PUBLIC MEETING SUMMARY SH-136

from US-412 south 2.5 miles City of Guymon / Texas County Job Piece Number 24413(04)

OKLAHOMA DEPARTMENT OF TRANSPORTATION

For Public Meeting Held November 8, 2018 At Texas County Activity Center

H. Property Owner south of US-412

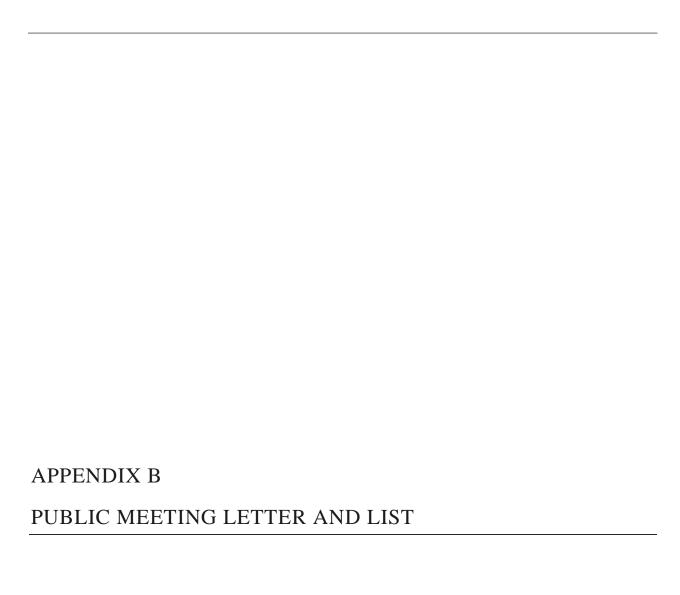
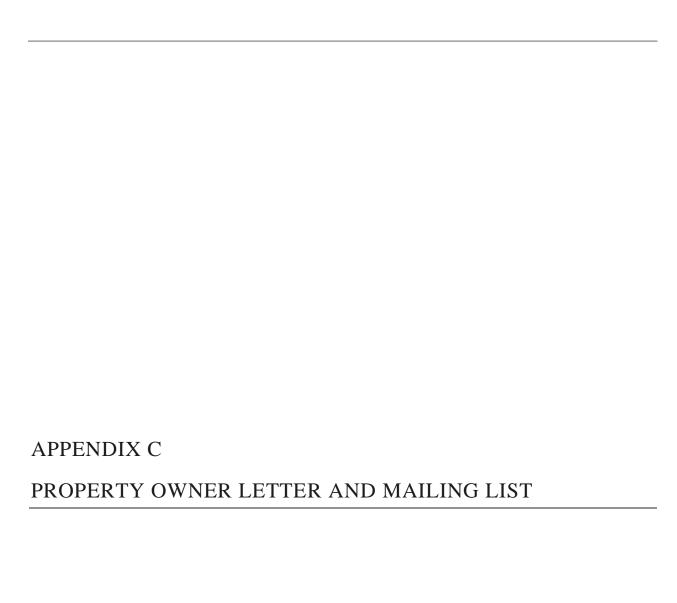
8a. Please keep me informed on the progress of the proposed update/change to SH-136. My company, The Odyssey Group LLC is the owner of the property on US Hwy 412 where the proposed alternative D would create an intersection with SH-136. If built, this road could make my remaining parcels on either side the new road so small that they would have no value for development. Please keep

this in mind if this project proceeds and a value is place on the land required for the road.

- 1. The east/west location of the proposed SH-136 intersection with US-412 was chosen to line up with Morgan Street that extends north of US-412.
- 2. There were multiple requests during the meeting to add a signal at this location. The City was supportive of this proposed signal. If signals are to be placed at this intersection, it is imperative that the proposed SH-136 lines up with Morgan Street. Unless Morgan Street is moved to the east, the proposed SH-136 cannot be moved to the east.
- 3. Also, moving the proposed alignment to the east would increase the noise levels at the apartment complex.
